Remarks

REPLACEMENT SHEET
"Absorbent Article With Dynamic Air Flow"
James A. Davis et al.
Docket #16,234

Serial No.: 09/866,326

FIG. 5

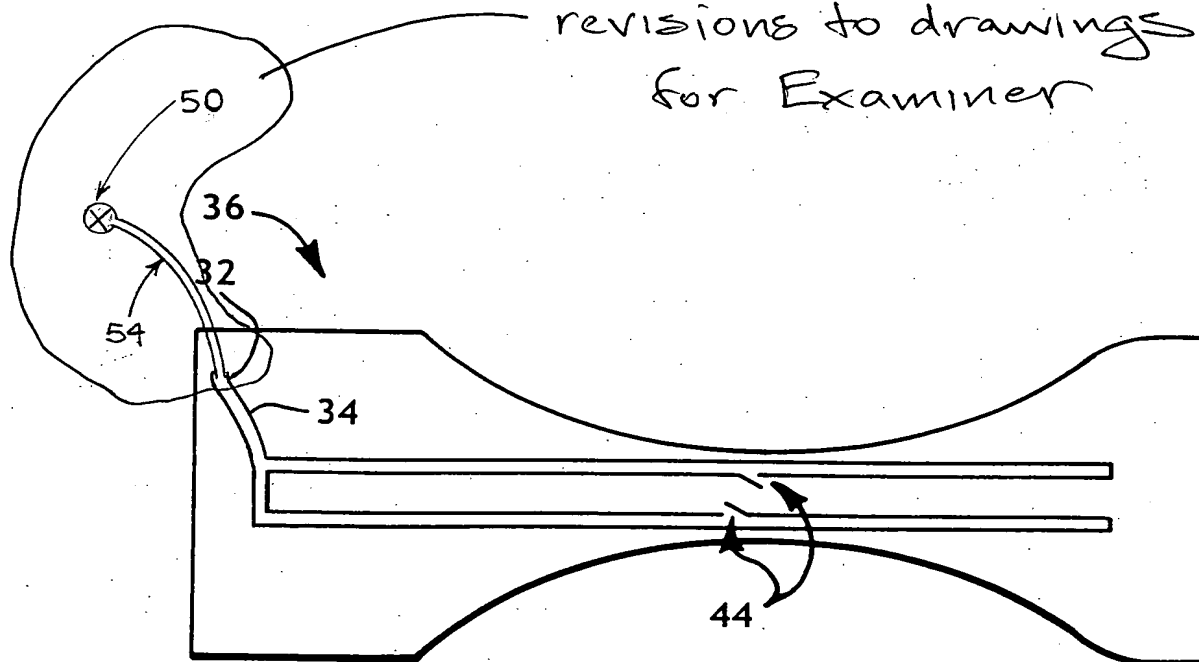
In paragraph no. 3, first item, the Examiner objected to the Description and Figures as being inconsistent. With this response Applicant submits proposed drawing changes which are included in this response as a REPLACEMENT SHEET for drawing sheet 3. Optional Annotated Sheets Showing Changes have also been included with this Response for the Examiner. Applicants submits that the Specification and Drawings are now consistent. Applicant further submits that the proposed drawing changes and accompanying REPLACEMENT SHEET adequately illustrate a means for connection 32 and an external means for pumping 50. Applicant has also amended the description of Figure 4 to clarify that an external means for pumping is not illustrated in Figure 4. Applicant submit that all of the objections to the drawings and related objections are resolved by the amendments to Figure 5 and the description of Figure 4. In the event that the Examiner disagrees with Applicant or suggests other changes, Applicant respectfully request the Examiner to contact the attorney of record via phone at 770-587-8620 to resolve any issues that the Examiner may have.

*marked copy
revisions to drawings
for Examiner*
